Technical Service Bulletin

Date Issued	Model Year(s) Affected	TSB #
11/09/2015	2010, 2012, 2013	429

Subject: Recall Campaign No 15V 585

Recall Service Bulletin

FIG. 3-1

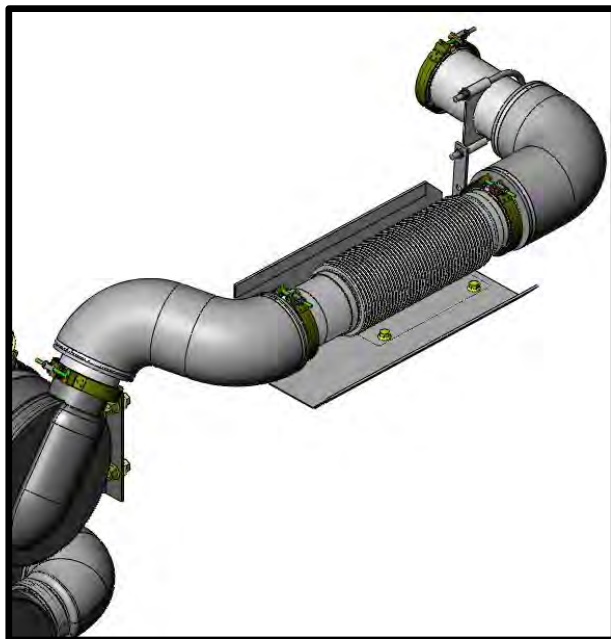
7. After completing alignment checks for the bellows/mating exhaust tubes and exhaust bellows has been removed: If alignment passes checks proceed to **step #9**. If alignment failed checks move to **step #8**.
8. Loosen clamps, support brackets, and v-band clamps that secure tubes to allow for adjustment of the tubes. Refer to 7th digit in VIN number for engine identification. If 7th digit is D, engine is an ISL: refer to FIG. 3-1. If 7th digit is E, engine is an ISX: refer to FIG. 3-2.

FIG. 4-1

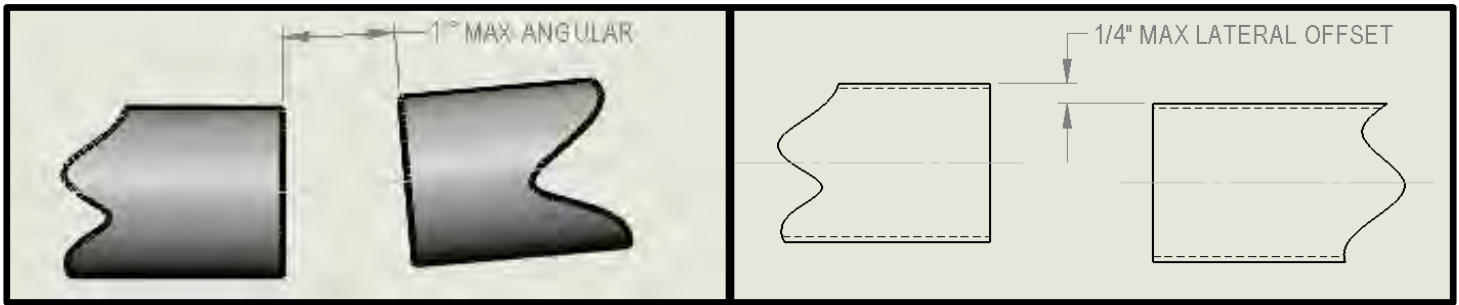
9. Install supplied bellows using supplied v-band clamps and gaskets. Leave clamps loose enough to allow for adjustment if required.
10. Using a straight edge, align tubes and exhaust bellows so they meet requirements for both angularity and lateral offset. The alignment must be checked in (2) two quadrants that are 90° apart. If **step #8** was skipped and proper alignment cannot be achieved **step #8** will need to be completed. Refer to FIG. 4-1.

11. Once alignment requirements are met secure all clamps and brackets.
12. Torque (4) v-band clamps to 90 lbs. in.
13. Ensure all other hardware has been tightened.
14. Recheck alignment to ensure no shifting has occurred.
15. Reinstall retained heat shields (if required).
